Well Name: JAMES RANCH UNIT Well Location: T23S / R31E / SEC 8 / County or Parish/State: EDDY /

#### **Notice of Intent**

**Sundry ID: 2870310**

## PLUG AND ABANDON WELLBORE JAMES RANCH UNIT 119H EDDY COUNTY, NEW MEXICO Class II

### JRU 119H - Proposed WBD

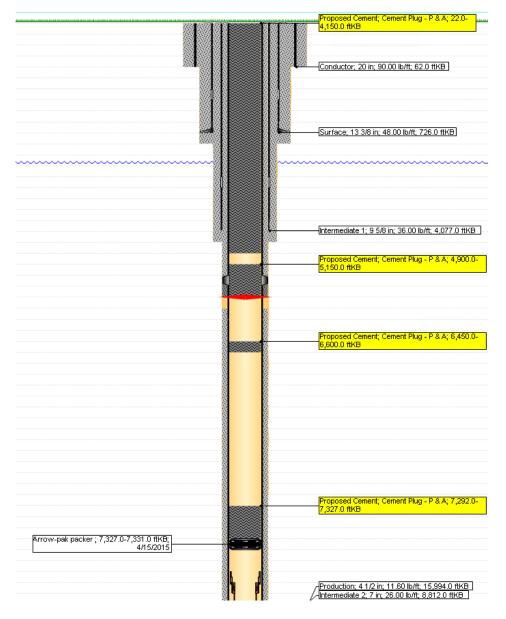
**REVISED**

REVISED
3:49 pm, Sep 03, 2025

Spot Class C cement from 4,150' to surface. 675 sxs Class C.

Perf and attempt squeeze 76 SKS from 5,150' to 4,865' Class C. WOC and Tag.

Spot 35 SKS **Class H** from 6,600′ to 6,450′. WOC and Tag.

Set CIBP at 7327'. Dump bail 35' Class H atop CIBP: 7,327' to 7,292'. PT CIBP to 500 PSIG for 30 min. WOC and Tag.
